SUMMARY MEETING NOTES
DOE/NRC MEETING ON HYDROLOGY TESTING
RICHLAND, WASHINGTON
JULY 11-15, 1983

Purpose: To discuss and begin the process of resolving the DSCA comments concerning the BWIP groundwater flow system

BWIP-NRC General Understanding on
Testing Strategy
July 14, 1983

MAJOR ACTIVITIES REQUIRED FOR HYDROLOGIC CHARACTERIZATION

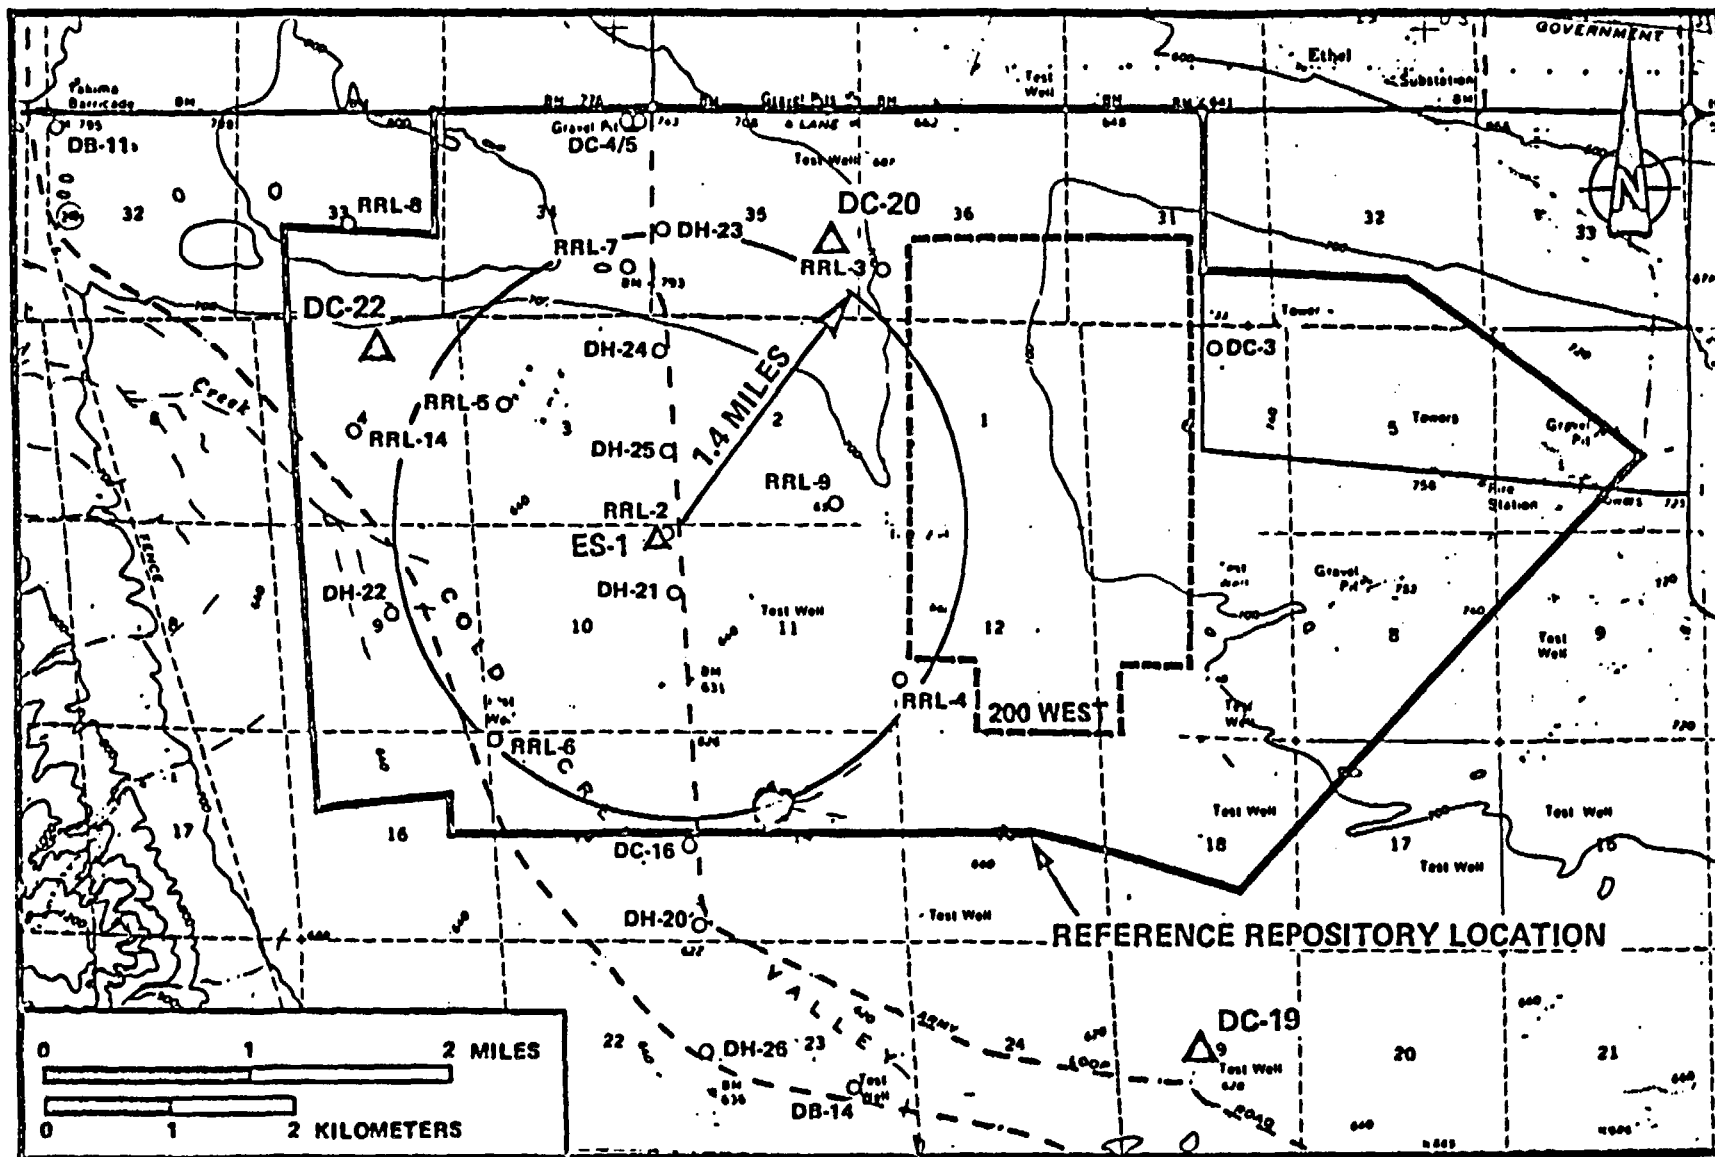
4.6 The tests proposed under "Large Scale Multiple Well Aquifer Testing" in viewgraph "Major Activities Required for Hydrologic Characterization" may not provide adequate information about the groundwater system near the repository. An understanding of this part of the system is needed to predict pre-emplacement groundwater travel time, as required by 10 CFR 60. The proposed pump test at RRL-2B, and related tests in the RRL, will address this matter.

Existing and Planned Boreholes In and Around the Reference Repository Location.

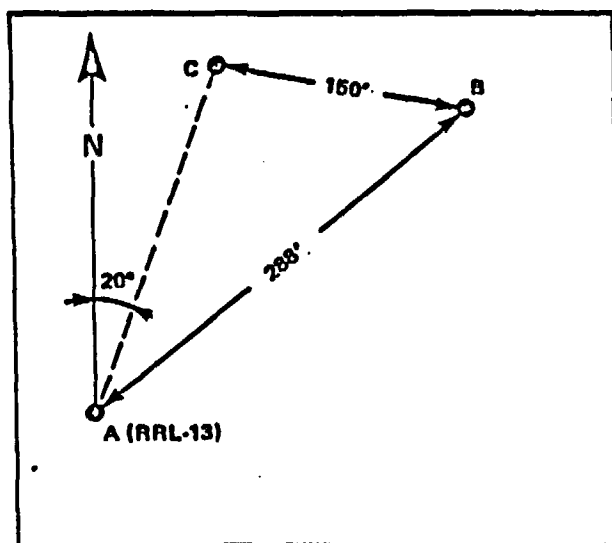
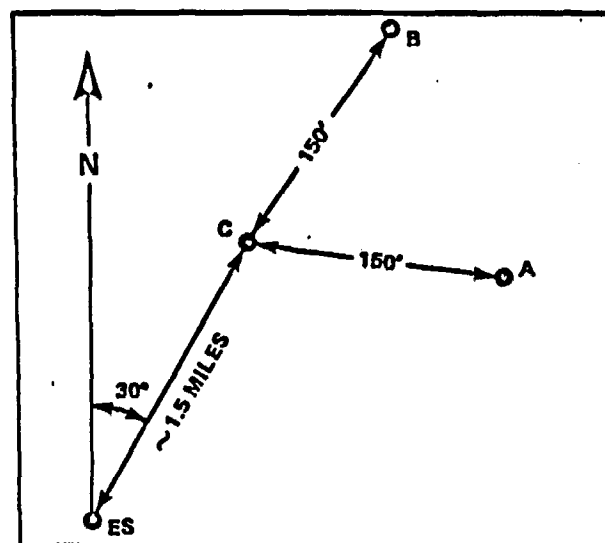
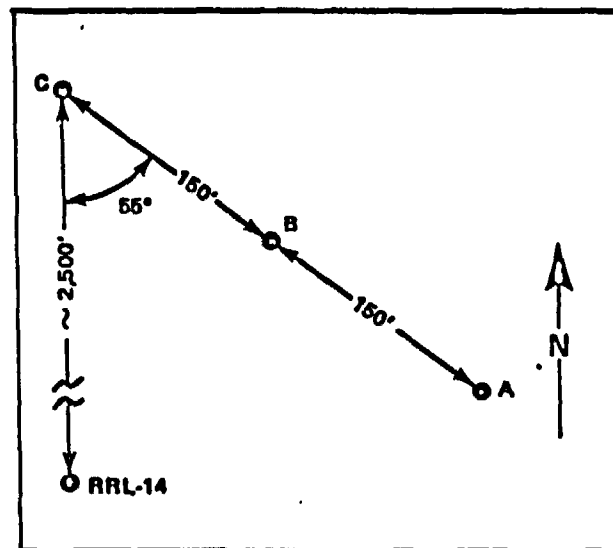
- 3.1 Plans (as presented) for installing piezometers are appropriate and should be implemented as soon as possible. Specifically, the number, location and air mist drilling methods for the piezometers including use of drilling mud through the Mabton, are appropriate.
- 3.2 The use of multiple-completion standpipe piezometers for long-term head measurements is appropriate.

Location of DC-16 Borehole Cluster.

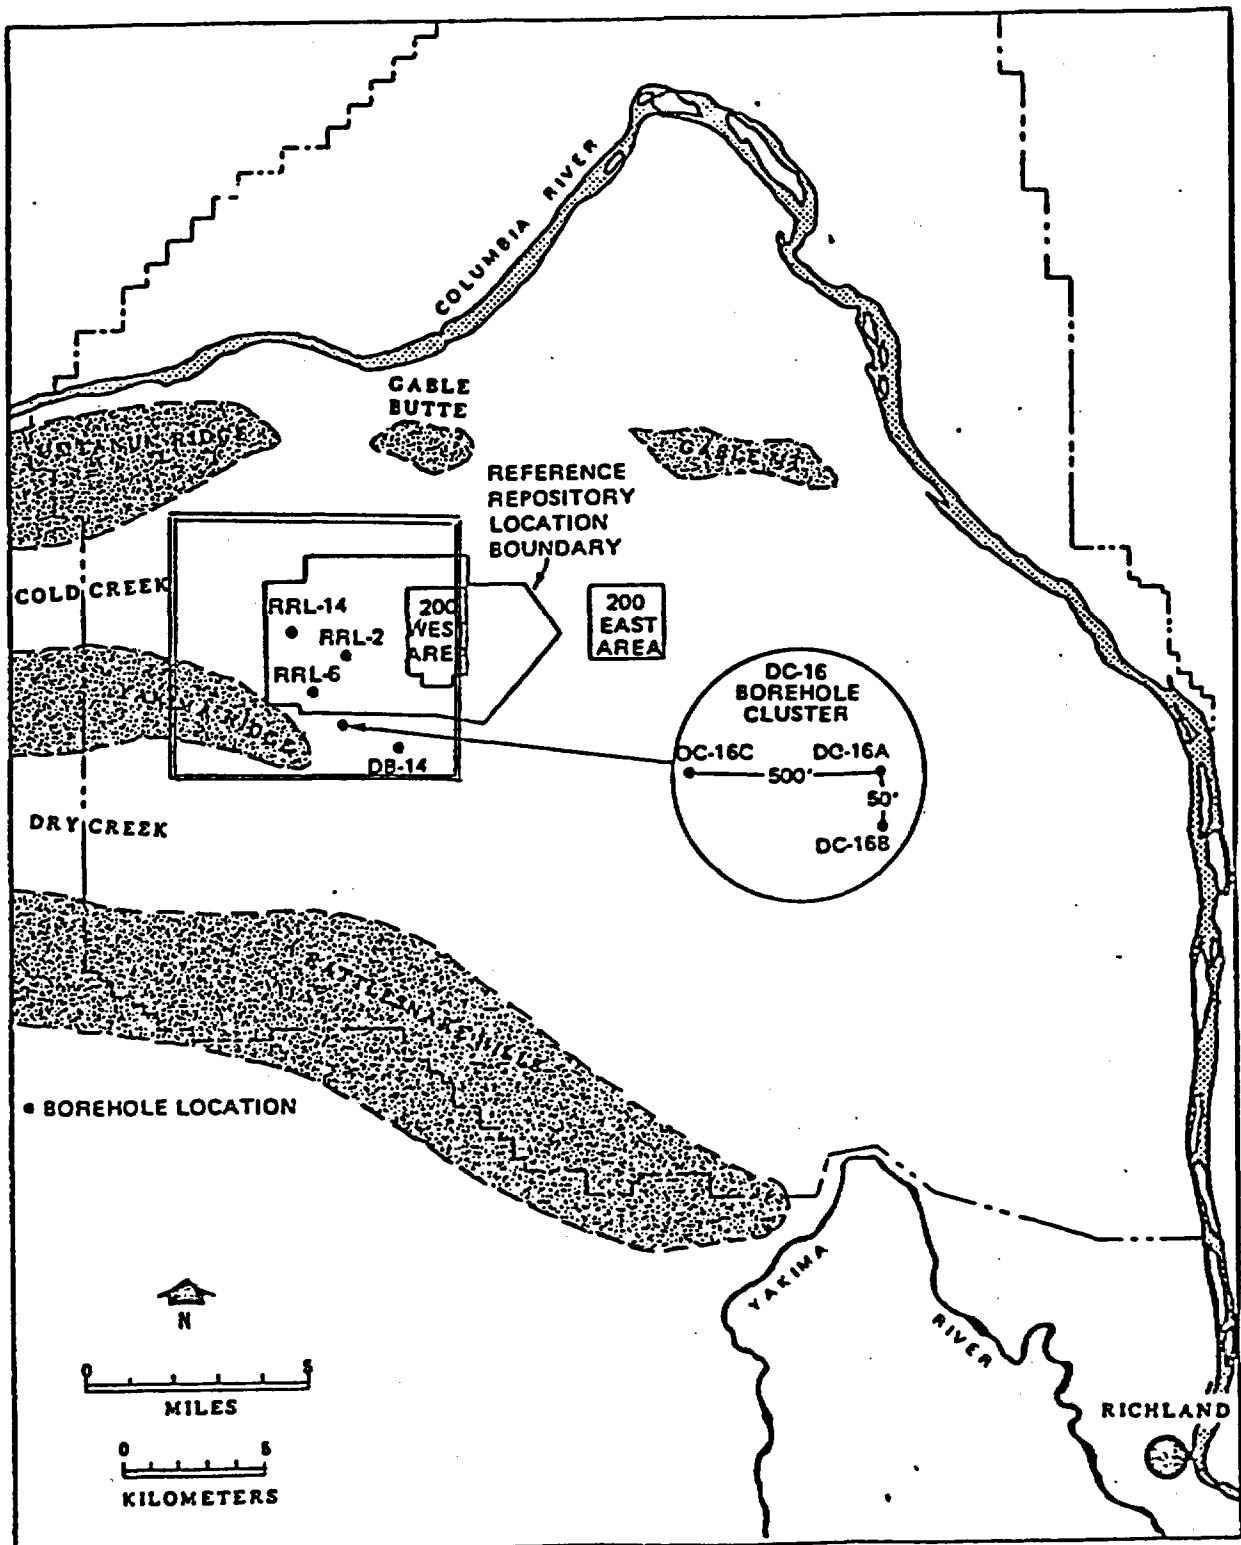
4.5 The approach to testing presented for the DC-16 borehole cluster test specification seems appropriate.
